ADDENDUM #8 TO:

**Project: ROK TAFE Consolidation Stg.2
- Design and Construct**

**Number: CQURFQ-26-4-DFM
Addendum Issue Date:
27/03/2026**

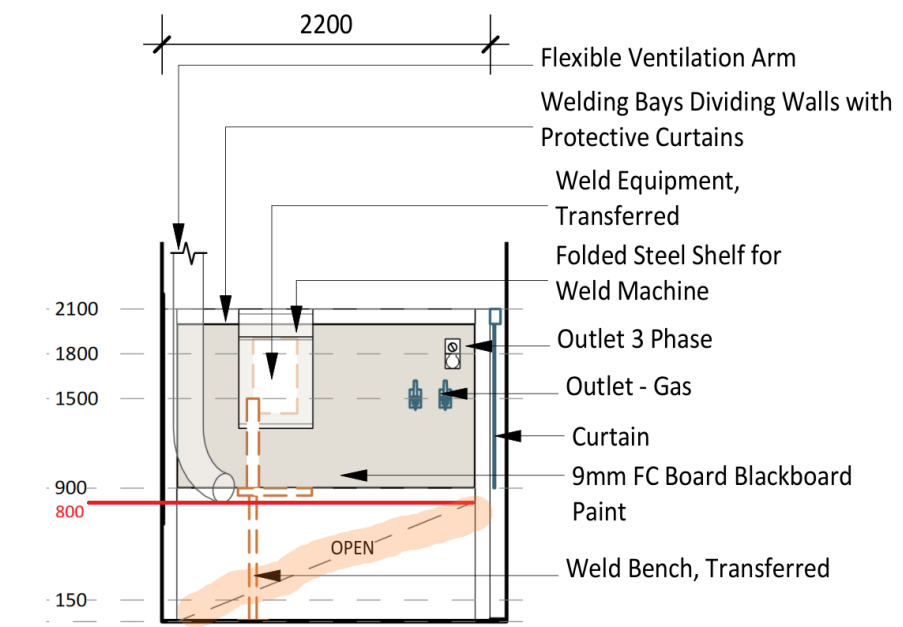
Regarding the welding bays – Can CQU confirm if the Blackboards are on all 3 sides? And if the dividers go all the way to floor or just a bit off for sweep out?

It looks like the dividers are 150mm off the floor and than the blackboard starts at 900mm?

Yes. Blackboard to all 3 sides. Dividers are to start at 800mm above floor. So dividers are open from floor level to 800mm. Refer to below elevation.

Dividers run to a height of 2100. Depending on the construction detail the blackboards are to run to approx. 2050mm.
